Subject: Safeguards Plan, Revision 42
Cooper Nuclear Station, NRC Docket 50-298, DPR-46

NEBRASKA PUBLIC POWER DISTRICT SAFEGUARDS PLAN

Revision 42

TABLE OF CHANGES

COOPER NUCLEAR STATION
SECURITY ORGANIZATIONAL CHART

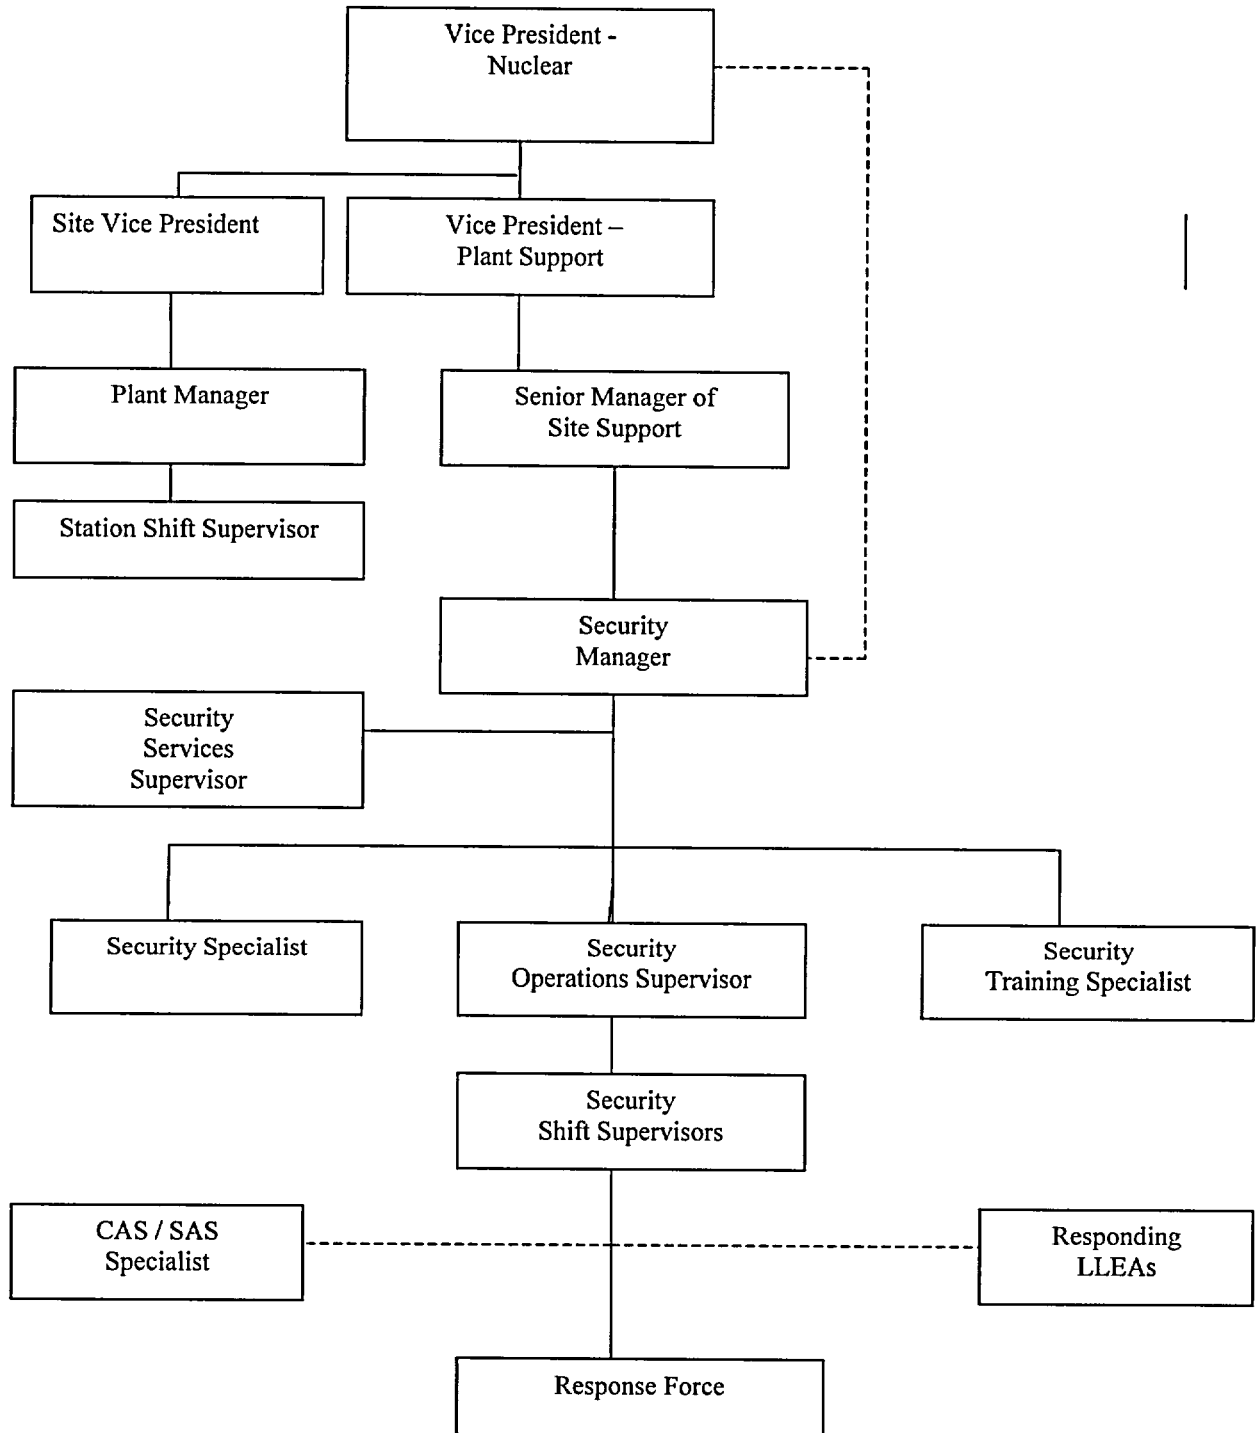
<u>PAGE</u>	<u>DESCRIPTION/REASON FOR CHANGE</u>
I-1-1	Change reporting relationship of Senior Manager of Site Support from the Vice President - Nuclear to the new position of Vice President - Plant Support.
I-A-1	Revise Security Organizational Chart to reflect the new position of Vice President - Plant Support, through which the Senior Manager of Site Support and the Security organization report.
